UNITED STATES PATENT AND TRADEMARK OFFICE

APPLICATION NO.	FILING DATE	FIRST NAMED INVENTOR	ATTORNEY DOCKET NO.	CONFIRMATION NO.
10/791,842	03/04/2004	Juncheng Xu	3811-008-27	3856

Office Action Summary	Application No. 10/791,842	Applicant(s) XU ET AL.	
	Examiner Samuel A. Turner	Art Unit 2877

DETAILED ACTION

FIG.4

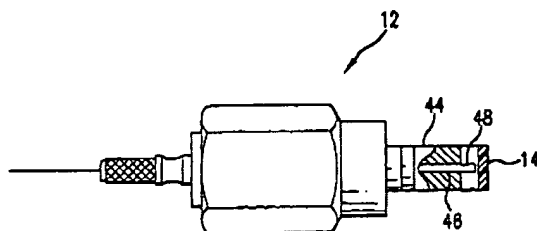
Claims 1, 10, 14, and 25 are rejected under 35 U.S.C. 102(e) as being clearly anticipated by Balachandran et al(6,901,176).

With regard to claim 1, Balachandran et al teach a sensor comprising:

a ferrule, the ferrule having a bore formed therein, the ferrule having a face, the face having a pit formed therein, the pit having a wider diameter than a diameter of the bore, the bore intersecting the pit(44);

a diaphragm attached to the ferrule such that it extends over the pit, the diaphragm having an inside reflecting surface facing the pit(14); and

a fiber disposed within the bore, an end of the optical fiber and the inside reflecting surface of the diaphragm being spaced apart to form a Fabry-Perot cavity(46).

As to claim 10, wherein the diaphragm is disc-shaped and has a circumference approximately equal to the circumferences of the ferrule(14).

With regard to claim 14, Balachandran et al teach a method for forming a sensor comprising the steps of:

forming a pit in a face of a ferrule, the ferrule having a bore formed therein, the pit being formed such that it intersects the bore(44);

attaching a diaphragm to the ferrule such that it extends over the pit, the diaphragm having an inside reflecting surface facing the pit(14);

disposing a fiber within the bore(46); and

attaching the fiber to the ferrule, an end of the optical fiber and the inside reflecting surface of the diaphragm being spaced apart to form a Fabry-Perot cavity(see figure 4; column 9, lines27-34).

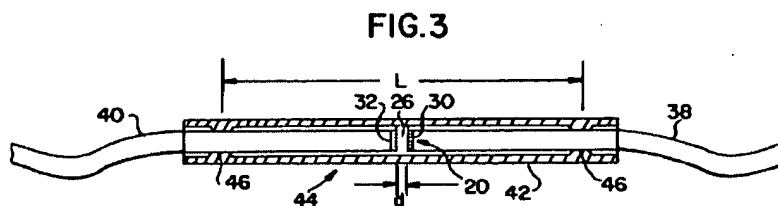
Claims 2-4, 15-17, and 29-32 are rejected under 35 U.S.C. 103(a) as being unpatentable over Balachandran et al(6,901,176) as applied to claims 6-9, 11-13, 19-24, and 26-28 above, and further in view of Belleville et al(5,202,939).

disposing an optical fiber within the bore, the optical fiber having an end, the end being spaced apart from the inside reflecting surface of the diaphragm, the end of the optical fiber and the inside reflecting surface of the diaphragm forming a Fabry-Perot cavity(46). However, Balachandran et al fail to teach the specific means by which the sensor elements are connected.

Belleville et al teach that elements in a Fabry-Perot fiber sensor can be connected(46) by welding using either a CO2 laser or electric arc(column 6, lines 17-21).
